Access Compliance Report

Public Rights-of-Way

(Curb Ramps)

Intersection ID: 13932	Main Street: LORNA_ST	Cross Street: COMMONWEALTH_AV	Location: S
ADA ID: 7FE6AF13BD8B	Ramp Type: Perp	Initial Pass/Fail: Fail	Overall Compliance: No
Codes/Mitigation Info/Possible Solution		Field Measurements/Component Compliance

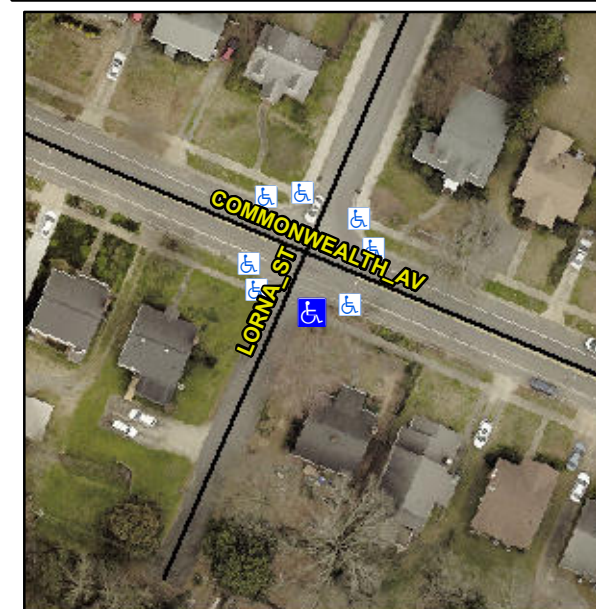
Not Found, R304.2.2, R304.5.3

Compliance	Description	Data	Compliance	Description	Data
N/A	Ramp Length (in)	46.5	No	Ramp Slope (%)	11.0
Yes	Ramp Width (in)	48.0	No	Ramp XSlope (%)	5.0
N/A	Flare Type LT	N/A	N/A	Flare Type RT	N/A
N/A	Flare Slope LT (%)	N/A	N/A	Flare Slope RT (%)	N/A
N/A	Flare Traversable LT?	N/A	N/A	Flare Traversable RT?	N/A
N/A	Landing Length (in)	N/A	N/A	DWS Provided?	N/A
N/A	Landing Width (in)	N/A	N/A	DWS Contrast?	N/A
N/A	Landing Slope (%)	N/A	N/A	DWS Length (in)	N/A
N/A	Landing X Slope (%)	N/A	N/A	DWS Full Width?	N/A
N/A	Landing Curb? (Y/N)	N/A	N/A	DWS Offset (in)	N/A
N/A	Shared Landing?	N/A			
N/A	Gutter Ponding?	N/A	N/A	Gutter Slope (%)	N/A
N/A	Gutter Lip Ht (in)	N/A	N/A	Gutter X Slope (%)	N/A
N/A	Painted X Walk1?	No	N/A	Painted X Walk2?	N/A
	X Walk 1 Direction	To NW		X Walk 2 Direction	N/A
N/A	X Walk 1 Width (in)	N/A	N/A	X Walk 2 Width (in)	N/A
	X Walk 1 Slope (%)	6.7		X Walk 2 Slope (%)	N/A
	X Walk 1 X Slope (%)	4.7		X Walk 2 X Slope (%)	N/A

Remove & Replace Entire Ramp.
